## 18C Operator Interface Equipment Characterization

The information in this appendix of the reference ABWR DCD, including all subsections and figures, is incorporated by reference with the following departures and a supplement.

Figure 18C-8 Overall Configuration of Operator Interface System

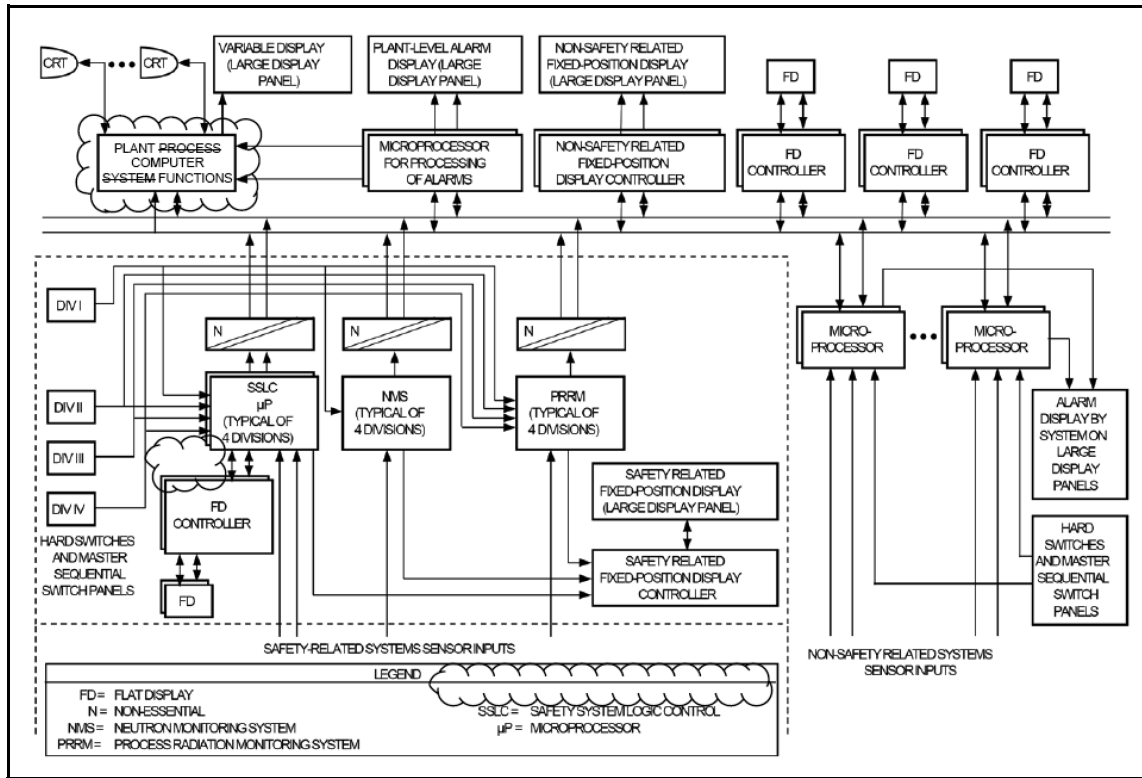
STD DEP T1 3.4-1 (Figure 18C-8)

*A characterization of the plant instrumentation and control systems architecture which supports the control room operator interface is illustrated in Figure 18C-8. As shown in Figure 18C-8, display and control capability for both safety-related and non-safety-related systems are driven by microprocessors which are independent of the redundant plant process computer functions. This assures the ability to safely shut down the plant in the unlikely event of computer failure. In the case of the safety-related systems, the microprocessors are divisionally dedicated and are each electrically isolated from the rest of the system.*

The instrumentation and control systems architecture is not identical to the conceptual design described in Appendix 18C. The changes in the next paragraph reflect the architecture and configuration.

~~The plant wide, fiber optic Essential Multiplexing System (EMUX) provides the communications network for the system. This multiplexing system is actually a series of data acquisition and control networks, separate networks being provided for safety related and non safety related plant systems.~~ The data communication function includes both safety-related and non-safety-related communication performed by separate networks as described in Section 7.9S.
